- A. Project Name: **Public Works Garage and Salt Shed**
- B. Owner: **City of Chester**
- C. Owner Project Number: **2025-010**
- D. Architect: **CED Architecture, Inc.**
- E. Architect Project Number:
- F. Date of Addendum: **05/27/2025**

##### **A. Addendum No. 02**

- A. Project Name: **Public Works Garage and Salt Shed**
- B. Owner: **City of Chester**
- C. Owner Project Number: **2025-010**
- D. Architect: **CED Architecture, Inc.**
- E. Architect Project Number:
- F. Date of Addendum: **06/02/2025**

G002

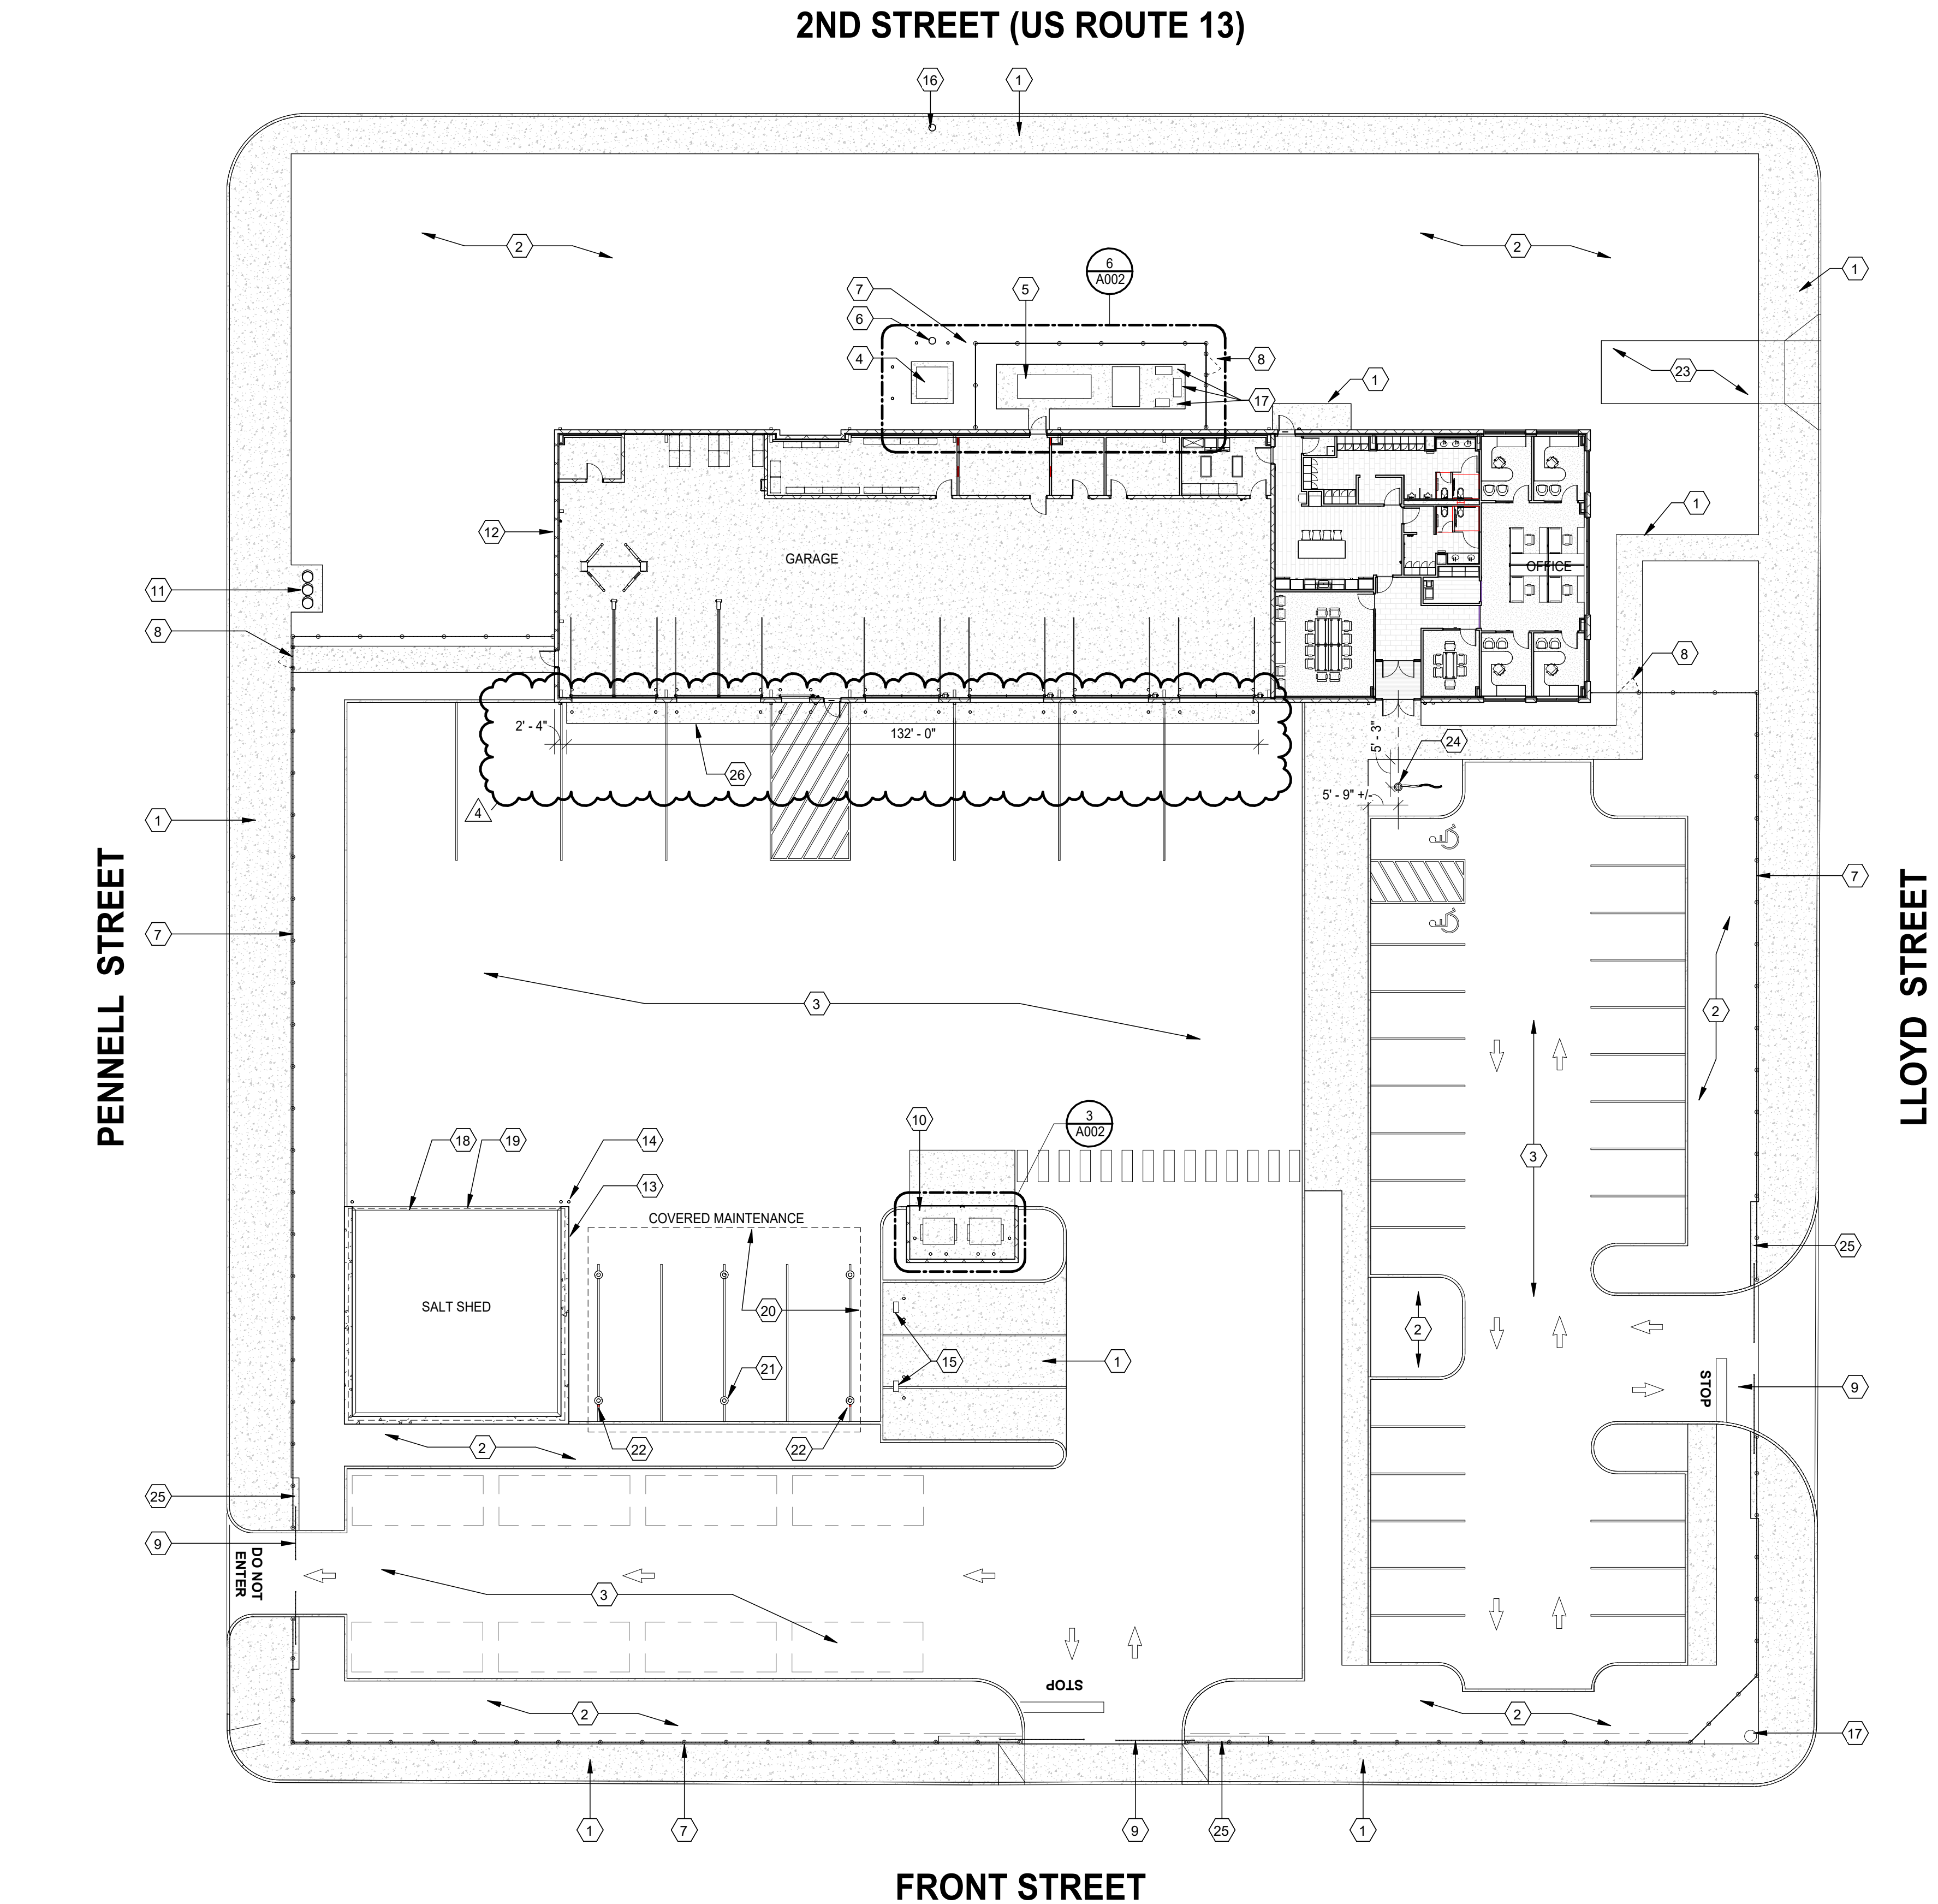
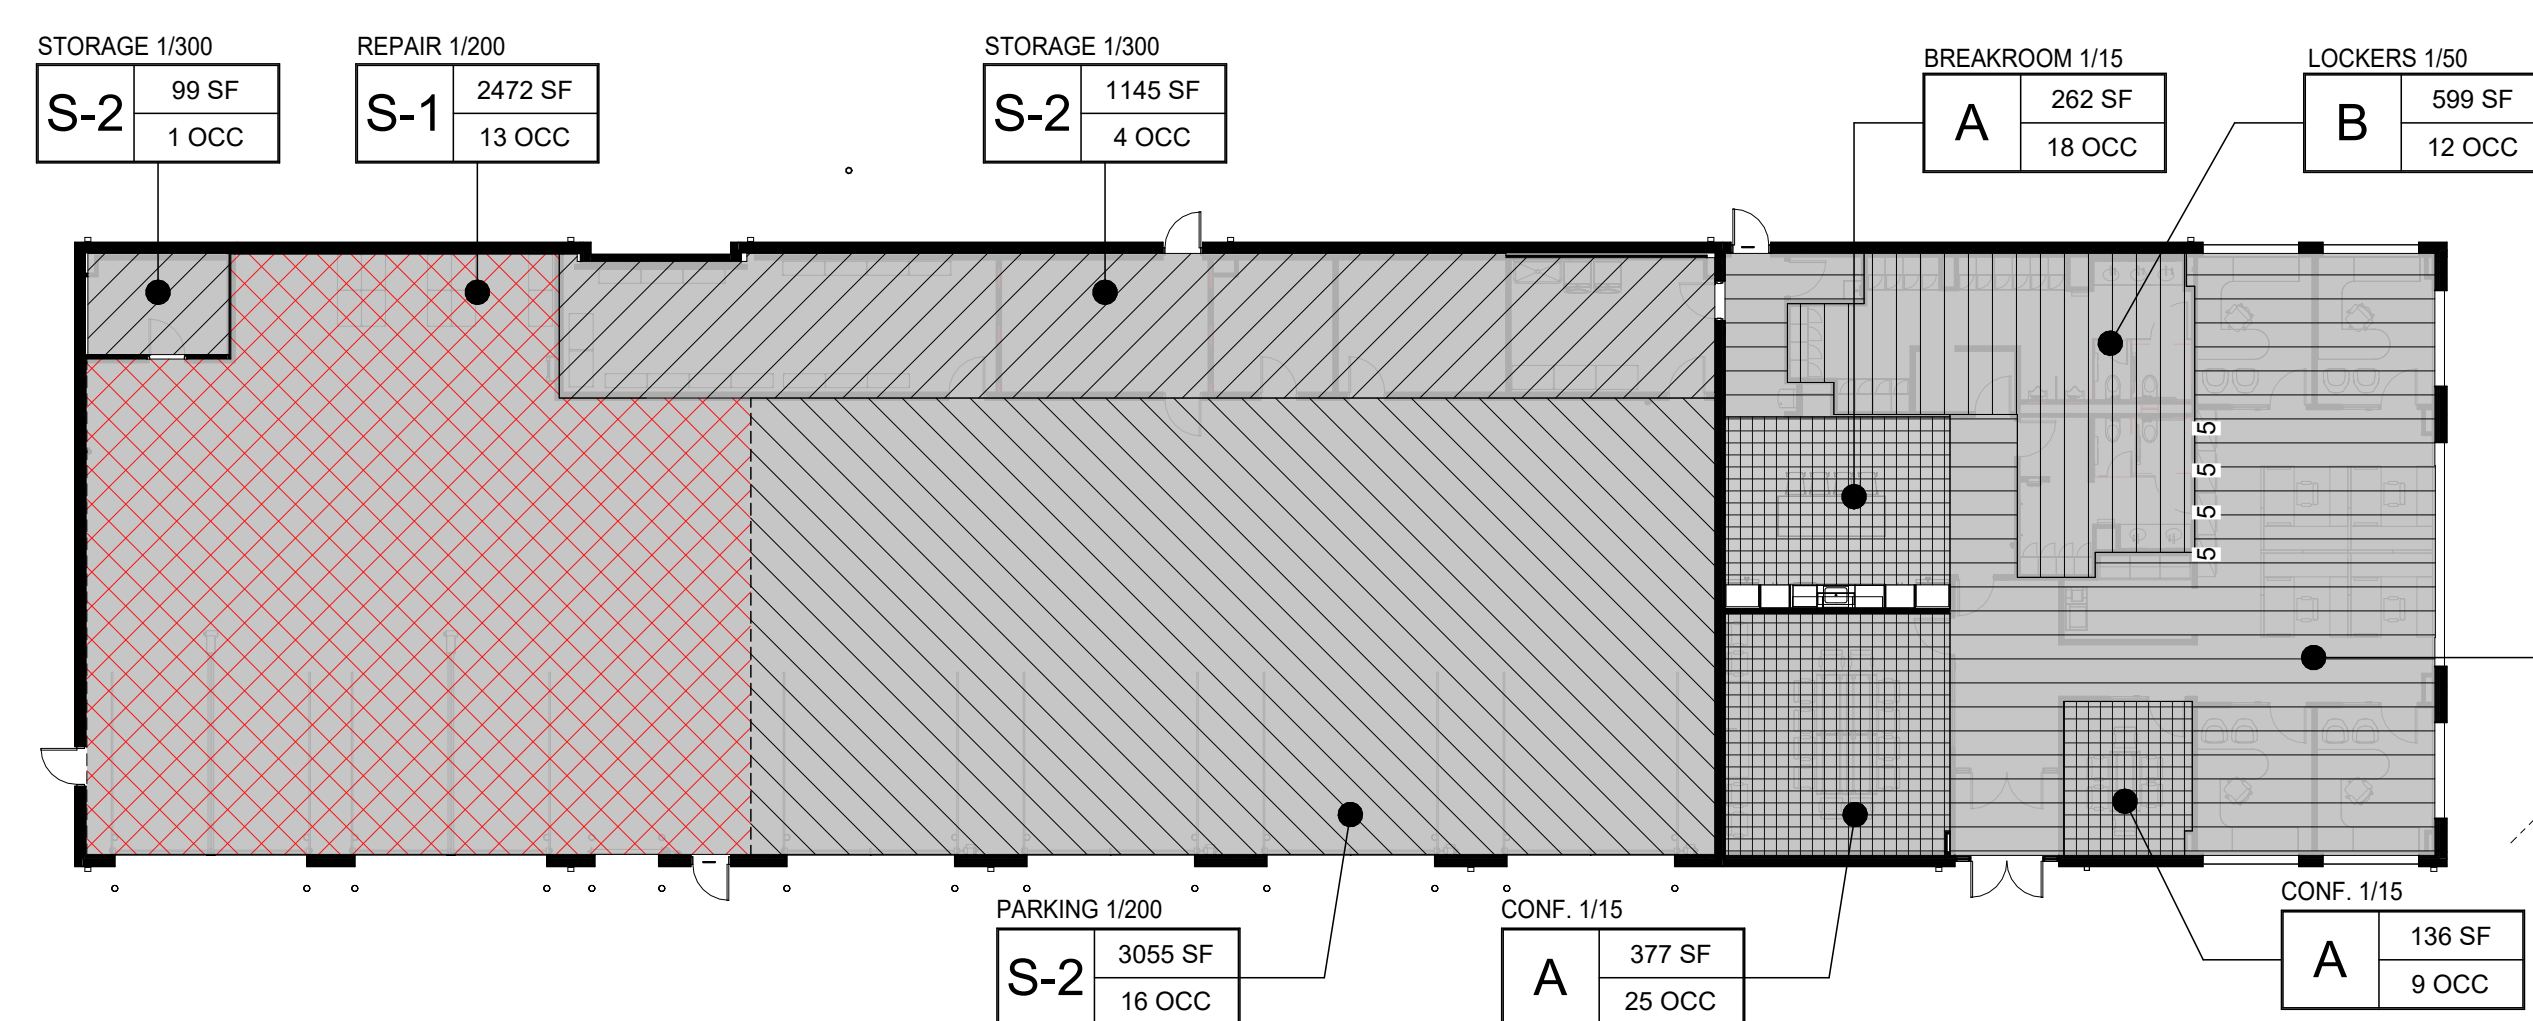
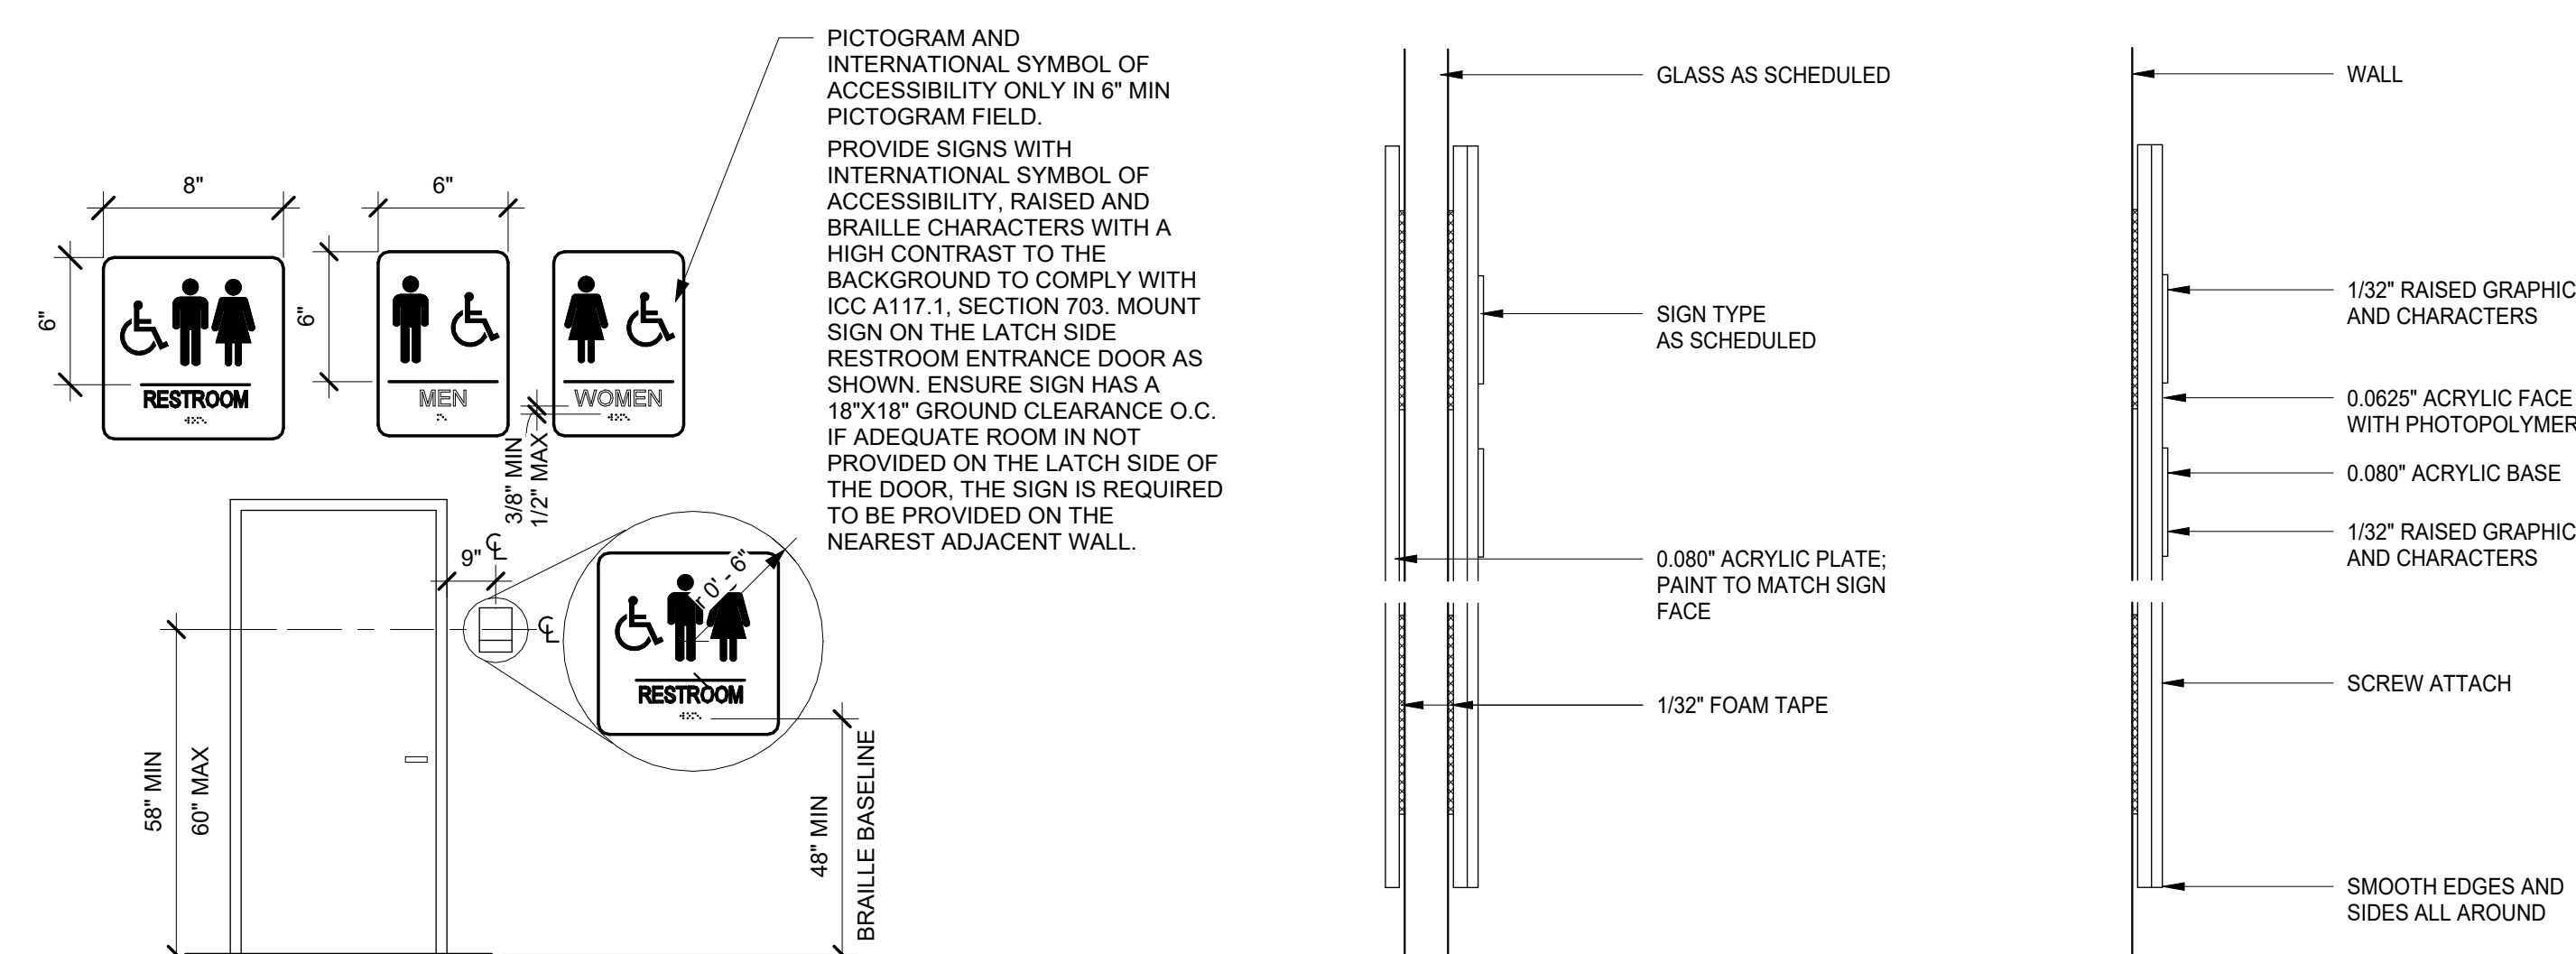
1. The below revision correlates with PennBid RFI response #109
  - a. **Drawing #1/G002:** "LIFE SAFETY PLAN" has been revised to show the location of interior tactile signage.
  - b. **Keyed Notes:** Keynotes #4 & #5 have been added to indicate additional work scope for interior signage.
  - c. **Interior Signage Schedule - "G":** Schedule has been added to identify interior signage types.
  - d. **Interior Signage Details:** Details #4, #5, #6 & #6 have been added to indicate signage graphic and installation requirements.

1 01 - FIRST FLOOR - ARCHITECTURAL SITE PLAN  
SCALE : 1" = 20'-0"

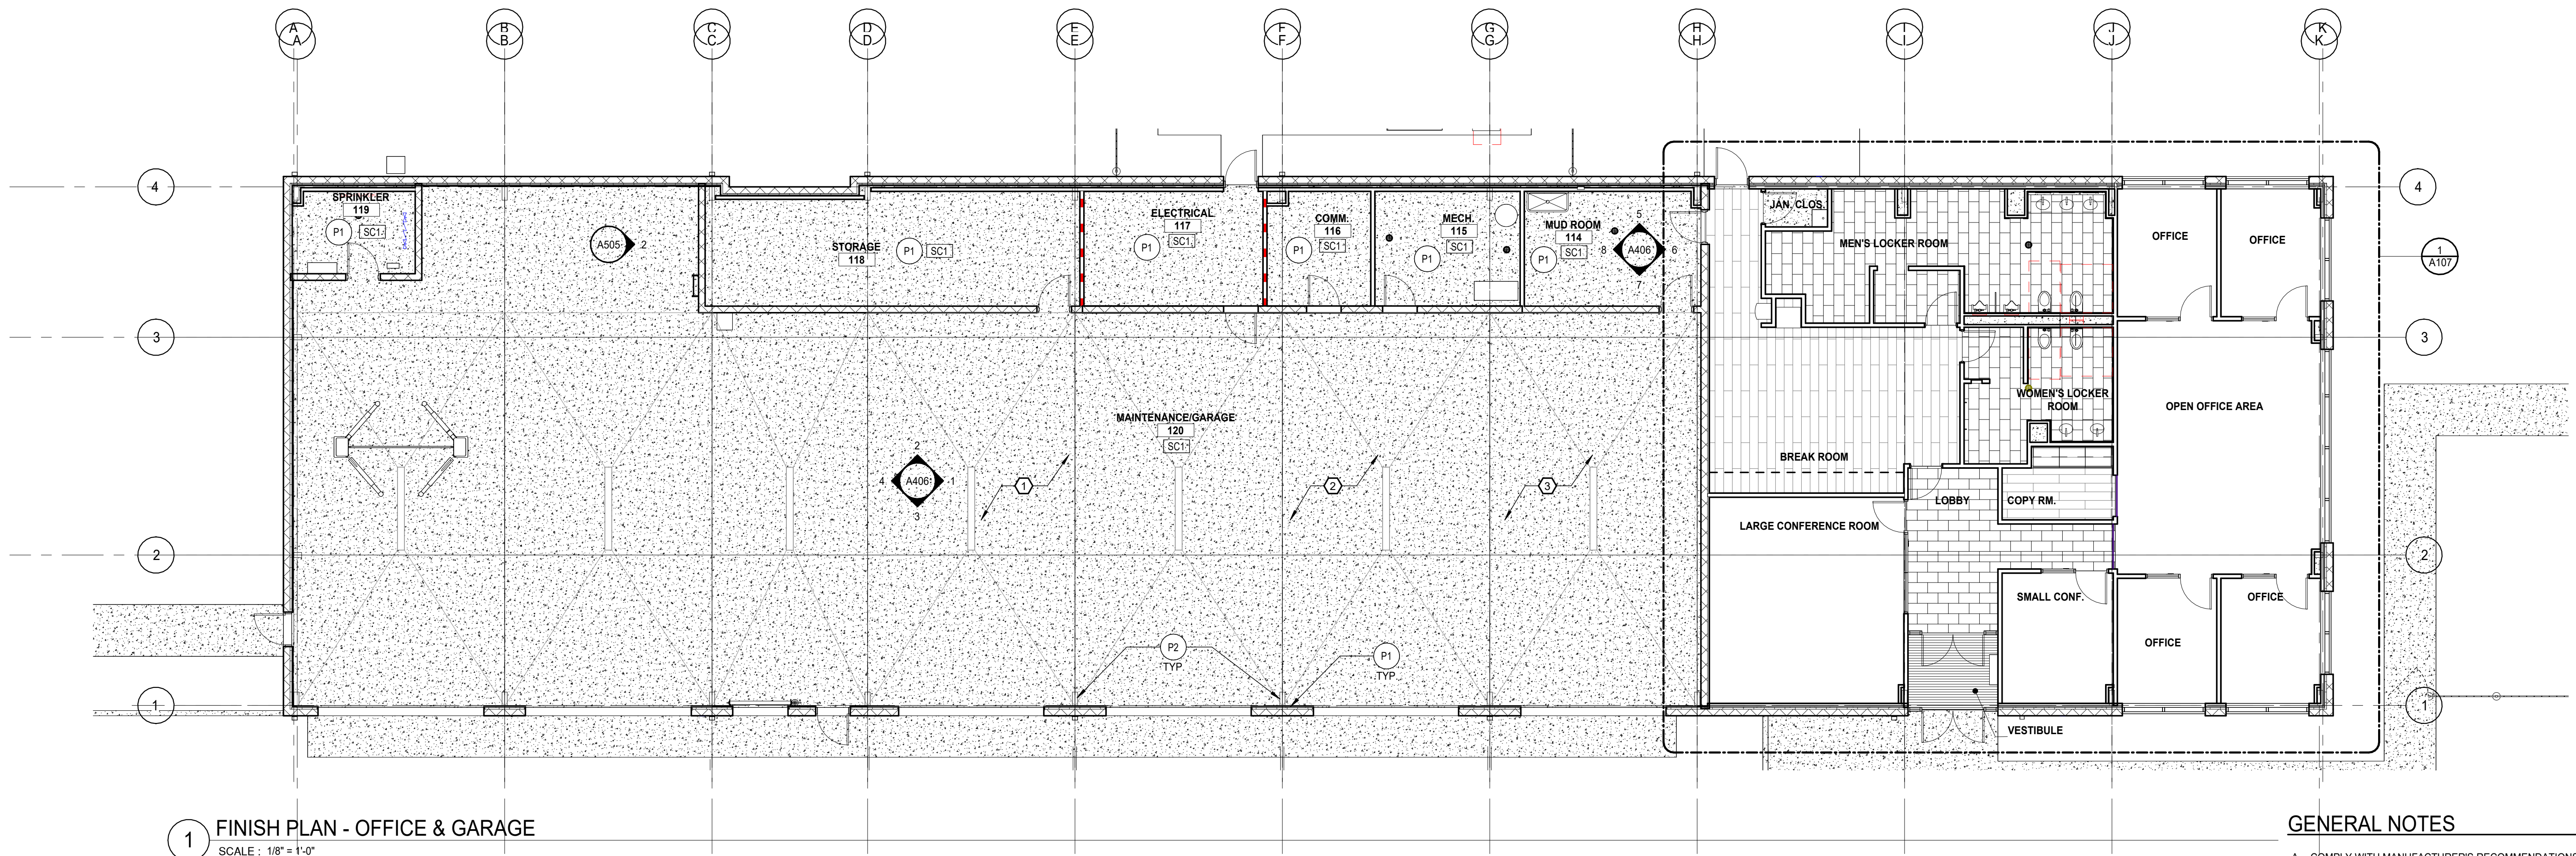
1. The below revision correlates with PennBid RFI response #99
  - a. **Keynotes:** Keynote #13 has been revised to indicate an expansion filler joint at perimeter of salt shed walls.
2. The below revision correlates with PennBid RFI response #108
  - a. **Plan #1/A001: Architectural Site Plan:** The extent of a concrete apron pavement area and keynote tag #26 have been added to indicate potential additional work scope in accordance with Alternate #9.

- b. **Keynotes:** Keynote #26 has been added to indicate potential additional work scope in accordance with Alternate #9.
